By email  
6 February 2026

Our ref 288776  
File ref ACD17

## NextDC B2 S2 Minor Height Reduction - Acoustic Impacts

Figure 1: Rooftop acoustic barrier / screen north elevation (Solid up to +8 m From Level 8 FFL). New solid parapet section highlighted in red

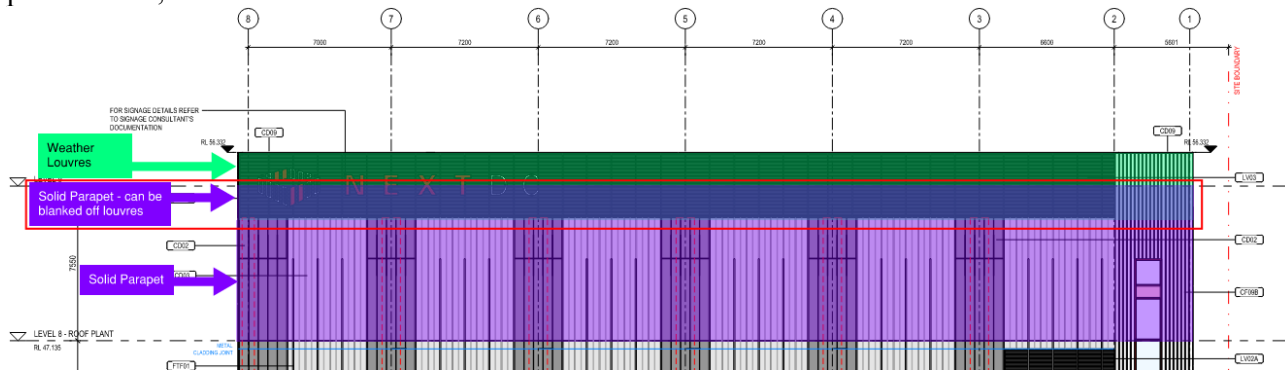
Based on the reduced building height, the acoustic assessment model has been updated to reflect the latest building design. Acoustic mitigation measures have also been updated, i.e. increase the height of the solid screen by 2 metres along the northern edge, as shown in the below figures.

The solid parapet section shall meet a minimum acoustic transmission loss of  $R_w + C_{tr} 31$ , indicative surface mass of  $13\text{kg/m}^2$ . This solid section can comprise a weather louvre with solid 9mm fibre cement sheet backing.
